DEVELOPMENT APPLICATION ASSESSMENT REPORT

Application Number:	DA2022/0688
----------------------------	-------------

Responsible Officer:	Adam Croft
Land to be developed (Address):	Lot 8 DP 3742, 35 Fairlight Street FAIRLIGHT NSW 2094 Lot 9 DP 3742, 33 Fairlight Street FAIRLIGHT NSW 2094
Proposed Development:	Demolition works and construction of a residential flat building
Zoning:	Manly LEP2013 - Land zoned R1 General Residential
Development Permissible:	Yes
Existing Use Rights:	No
Consent Authority:	Northern Beaches Council
Delegation Level:	NBLPP
Land and Environment Court Action:	Yes
Owner:	John William Allen
Applicant:	Allen Group Developments Pty Ltd

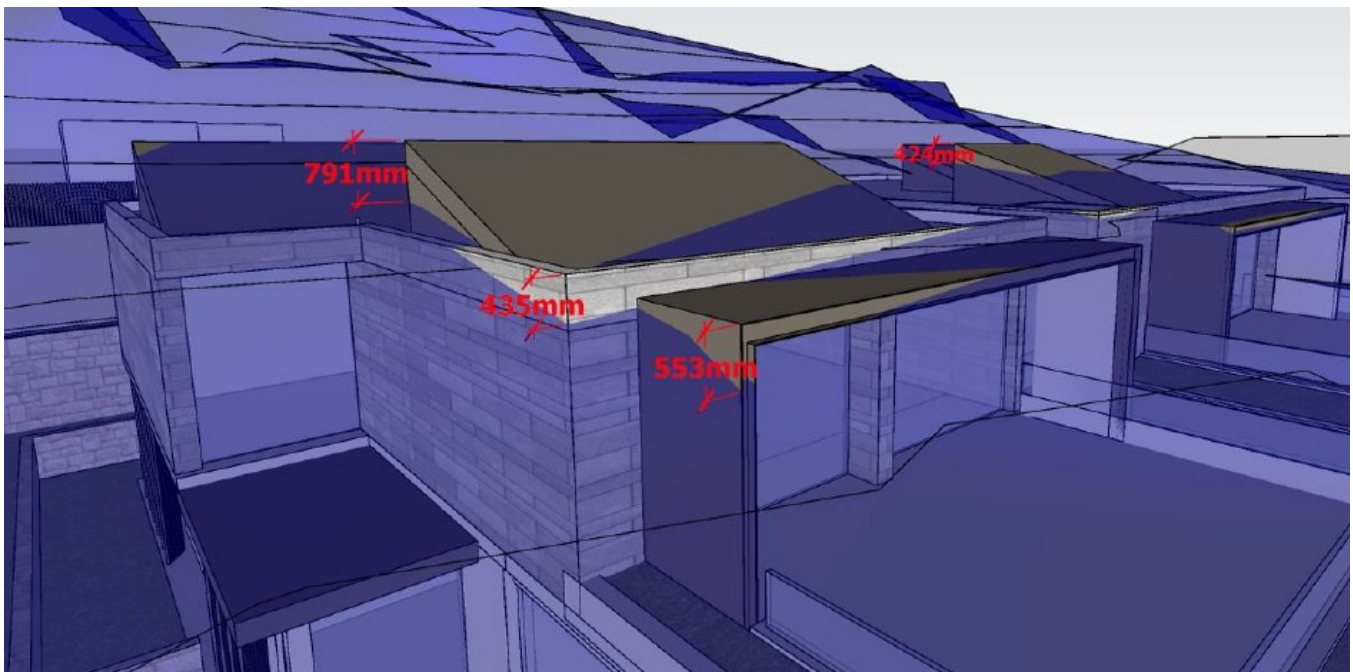
Development standard:	Height of buildings
Requirement:	8.5m
Proposed:	Existing ground: Insufficient information Natural ground: 9.291m
Percentage variation to requirement:	9.3%

The above height plane diagrams are not certified, however the portions of building projecting above the 8.5m height plane are generally in alignment with Council's calculations, and are presented in a more practical format than a two dimensional elevational drawing. On that basis, the diagrams can be used for assessment purposes.
